**STATEMENT OF PETER AMES EVELETH
GENERAL COUNSEL, OFFICE OF COMPLIANCE
BEFORE THE SUBCOMMITTEE ON THE LEGISLATIVE BRANCH,
HOUSE APPROPRIATIONS COMMITTEE
July 8, 2008**

Capitol Visitor Center
Office of Compliance
Pre-Inspection

**Eveleth Statement
Attachment 2**

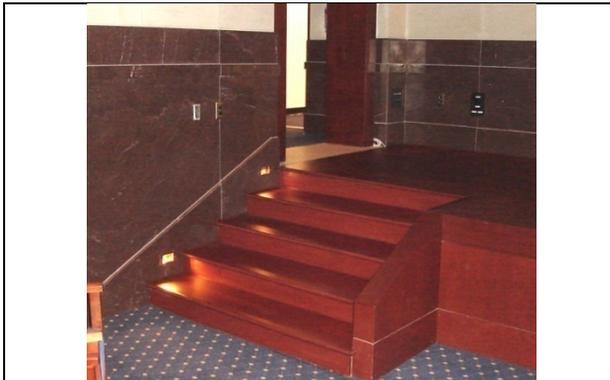
Violation: Ramp is too steep for individuals in wheelchairs and does not comply with 28 CFR Part 36 Appendix A Section 4.8.2.
Solution: Regrade ramp equal to or less than 8.3% grade.
